PUBLIC HEARING MEMORANDUM

SUBJECT: **Petition #446-22**, for SPECIAL PERMIT/SITE PLAN APPROVAL to allow a rear lot subdivision to construct a singlefamily dwelling and relocate the existing dwelling forward at 113 Grove Street, Ward 4, Newton, on land known as Section 43 Block 31 Lot 15, containing approximately 23,063 sq. ft. of land in a district zoned SINGLE RESIDENCE 3. Ref: 7.3.3, 7.4, 3.1.5, 3.1.10, 1.5.2.G.1 of Chapter 30 of the City of Newton Rev Zoning Ord, 2017.

113 Grove Street

ZONING REVIEW MEMORANDUM

Proposed site plan

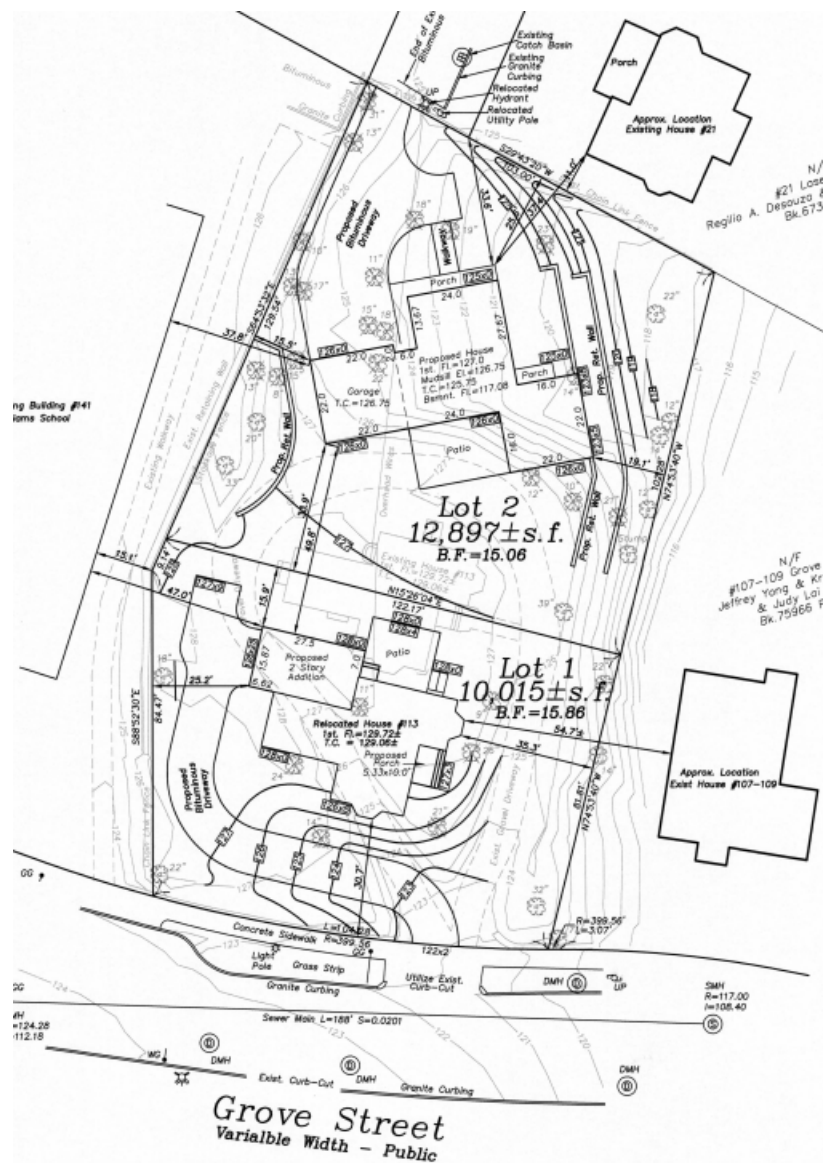
but expanded and relocated, existing two-story single-family dwelling. With 2,574 square feet of gross floor area, it would have a floor area ratio (FAR) of 0.26, below the 0.41 allowed by right. Its height, as measured above average grade, would be 29.98 feet, below the maximum 36 feet allowed. The Planning Department notes that the petitioner has seemingly not submitted architectural drawings for the to-be-relocated existing dwelling. These should be submitted, especially as additions to that structure are planned.

The lot's front setback would be 31 feet, slightly greater than the required 30 feet. The right (north) side setback would be 35.3 feet and its left (south) side setback would be 25.2, both well above the required 10 feet. The rear (west) setback would be conforming at 15.4 feet, just above the 15 feet required. The Lot Coverage would be 15.23%, below the maximum 20.0% allowed; the Open Space percentage would be 68.2%, above the required 50%.
